NOTICE OF PUBLIC MEETING

Governmental Body: Van Meter Planning and Zoning Commission

VAN METER, IOWA
HUDSON HEIGHTS PLAT 1
LONG RANGE STREET PLAN

VAN METER, IOWA
TRINDEL RIDGE
PRELIMINARY PLAT
REVIEW COMMENTS

VAN METER MASTER PLAN
VAN METER, IOWA
VAN METER CONCEPTUAL STREET LAYOUT

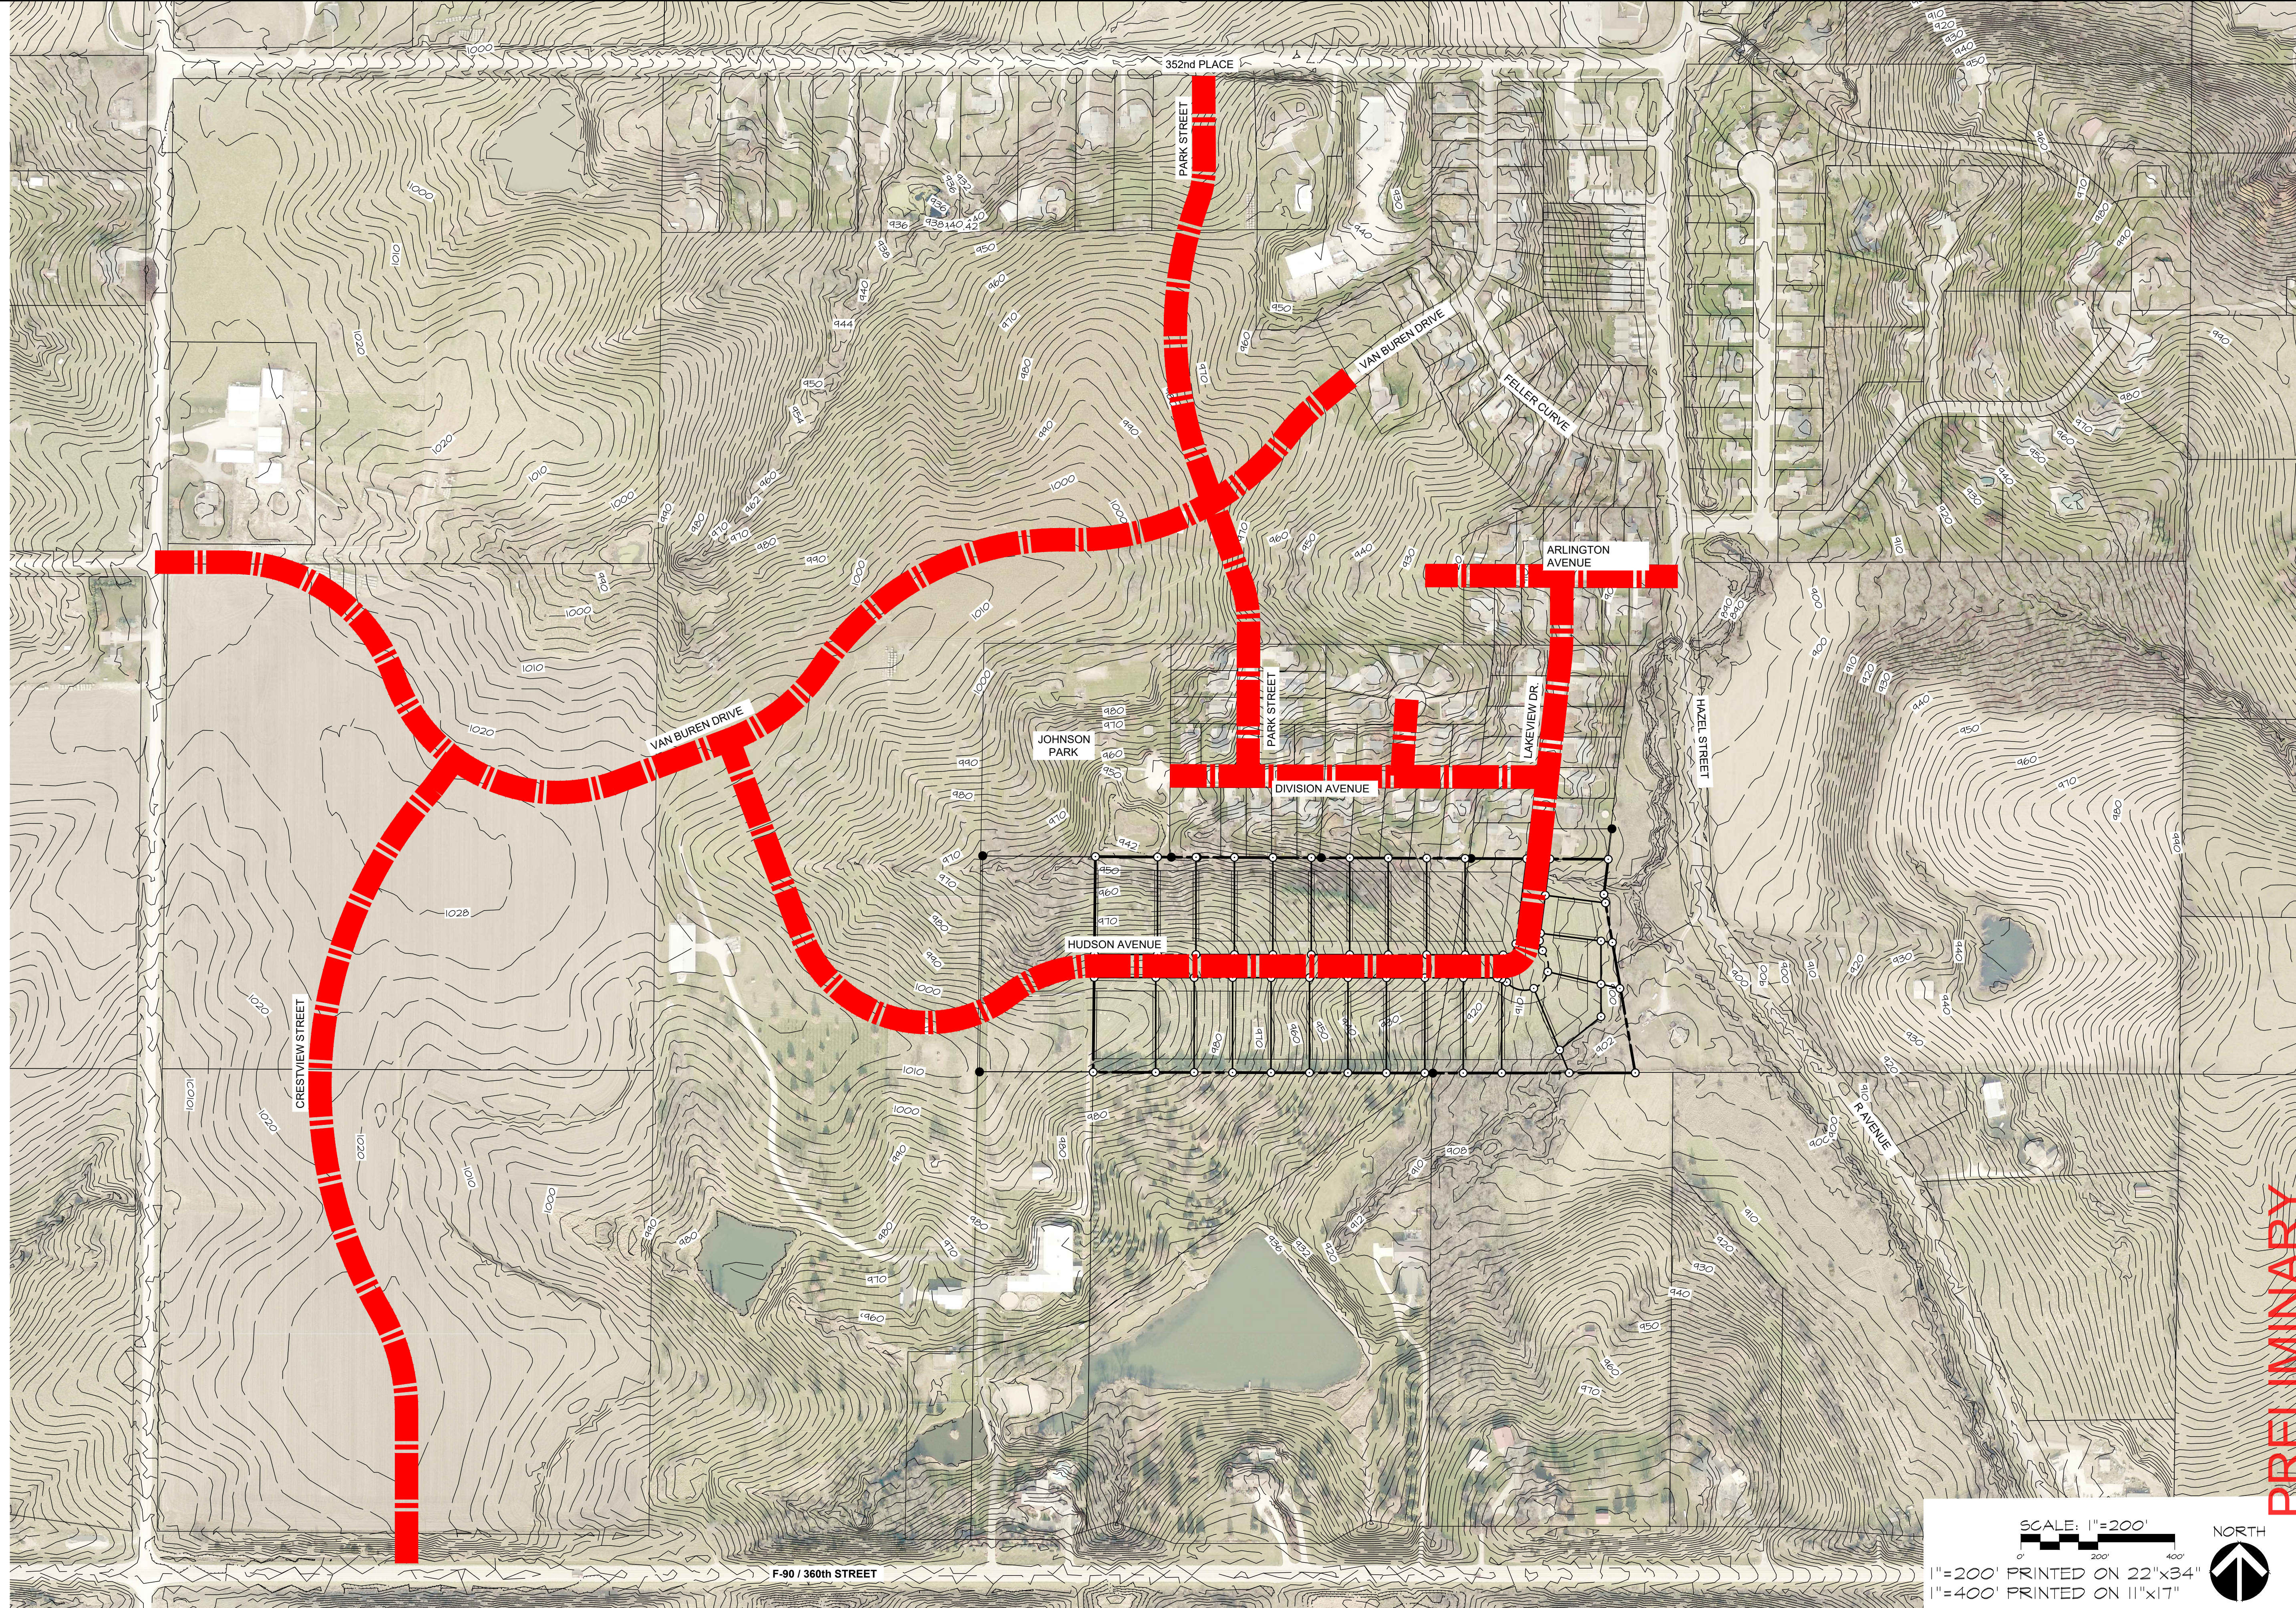
The writer has completed a review of the conceptual street plan developed by Civil Engineering Consultants, Inc. for the area west of Hazel Street and south of De Soto Road (352nd PI). For your information enclosed is the conceptual street plan.

The conceptual street plan shows Hudson Avenue extending westerly from Hudson Heights Plat 1 to connect to a future extension of Van Buren Drive. Van Buren Drive is shown to extend from its current terminus westerly to connect to the intersection of Old Portland Road and 355th Street.

The long range plan shows an extension of Park Street northerly to connect to De Soto Road (352nd PI). The long range street plan shows a future street extending from Van Buren Drive southerly to 360th Street (F90) along an alignment parallel to and easterly of Old Portland Road.

The street plan does not show the extension of two existing streets west of Hazel Street. The plan does not show Division Avenue extending westerly from its current terminus into the Johnson Park area. The plan does not show Arlington Avenue extending westerly to intercept the extension of Park Street.

In considering this long range street plan it is important to consider the slope of future streets. SUDAS has established design standards for residential and collector streets. SUDAS recommends a maximum slope of 12% in a residential zone and either 9% or 10% in a nonresidential zone with a speed limit of 25 miles per hour. As the speed limit increases, the percent of slope decreases. At 35 miles per hour the maximum recommended slope is 11% on local streets and 10% on a collector street.

Based on review it would be very difficult to extend Division Avenue either westerly or westerly and southerly within the 12% slope limitation without significant grading. While it would be

possible to extend Arlington Avenue westerly some distance at a slope of not greater than 12%, it appears marginal whether Arlington Avenue can connect to Park Street without at least some portion of the extension of Arlington Avenue exceeding 12%.

The writer is of the opinion the conceptual street plan set forth by Civil Engineering Consultants, Inc. is reasonable. If Hudson Avenue is to extend beyond the plat area a westerly extension is clearly preferred with that extension connecting to Van Buren Avenue. Excluding the extension of Division Avenue from a future interconnected street plan is reasonable, as any extension of Division Avenue would be very difficult without exceeding a slope of 12%.

With the connectivity at Van Buren and Park Street the interconnectivity with Arlington Avenue is much less critical. Unlike Division Avenue where it appears there is no reasonable alternative to extend Division Avenue, it would be possible to extend Arlington Avenue if the City was willing to accept reaches of street in excess of 12%.

While the future extension of Arlington Avenue may be viable for a local residential street, the writer would not consider the extension of Arlington Avenue a part of the interconnectivity plan as the goal would be to keep the major streets shown on the plan at slopes not exceeding 12%.
